Wisconsin Department of Transportation

Proposal #11: 9200-10-71, WISC 2019 634
Shawano – Green Bay
CTH VV Interchange
STH 29
Brown County

This is Addendum No. 02, which provides for the following:

ADDENDUM NO. 02
9200-10-71, 9200-10-72
August 28, 2020

Addendum No. 02
 ID 9200-10-71
 Revised Sheet 13
 August 28, 2020

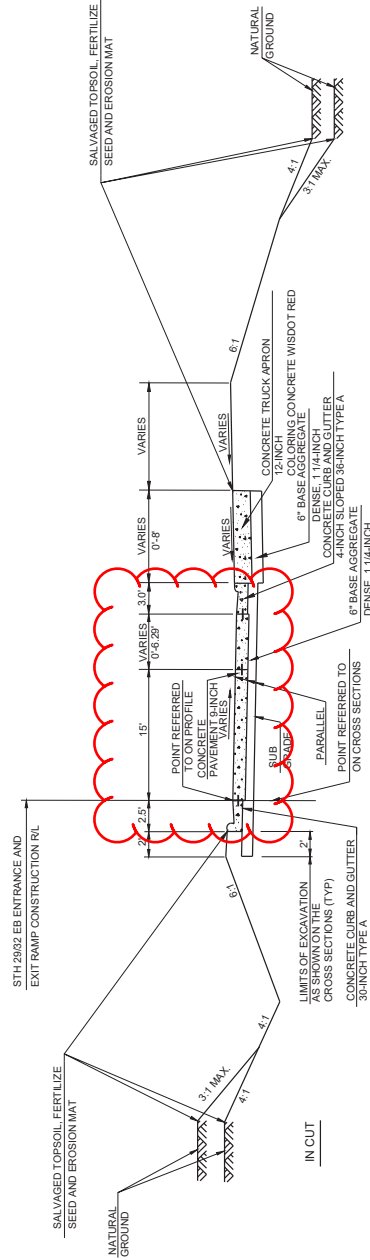
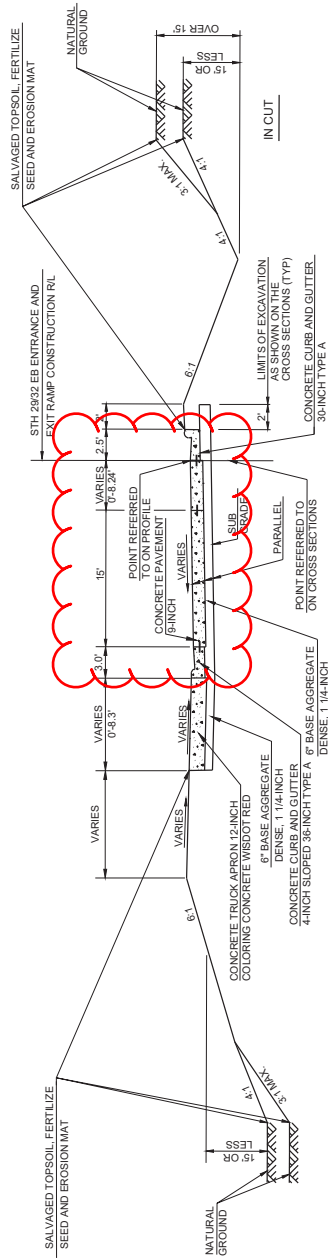
Revised Plan Sheets	
Plan Sheet	Plan Sheet Title (brief description of changes to sheet)
13	Typical Sections (Tie bar added)
14	Typical Sections (Tie bar added)
17	Typical Sections (Tie bar added)
546	Miscellaneous Quantities (Added item and update of quantities)
573	Miscellaneous Quantities (Added item)

Addendum No. 02
ID 9200-10-71
Added Sheet 660A
August 28, 2020

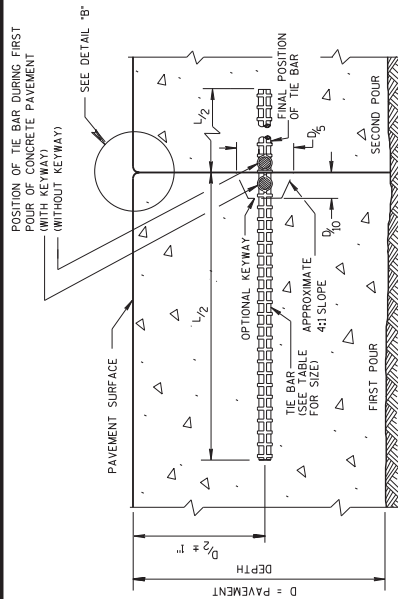
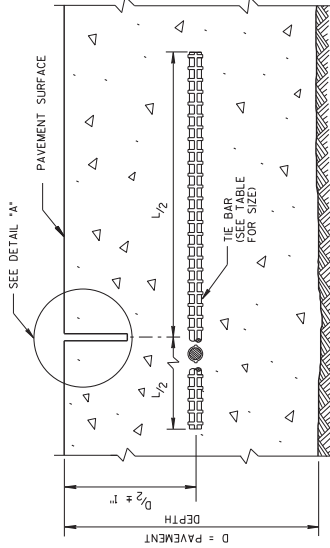
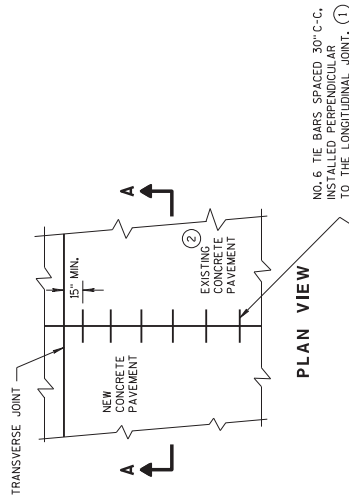
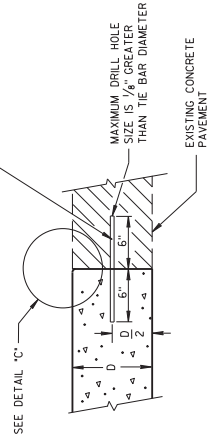
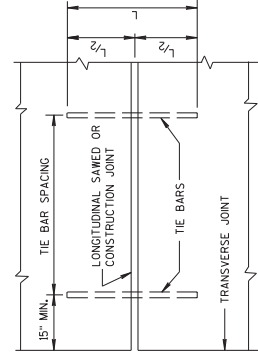
Added Plan Sheets	
Plan Sheet	Plan Sheet Title (brief description of why sheet was added)
660A	Standard Detail Drawing - Concrete Pavement Longitudinal Joints and Ties (Missing from plan)
712A	Standard Detail Drawing - Traffic Control, Lane Closure, Basic Traffic Queue Warning System (Added bid item)
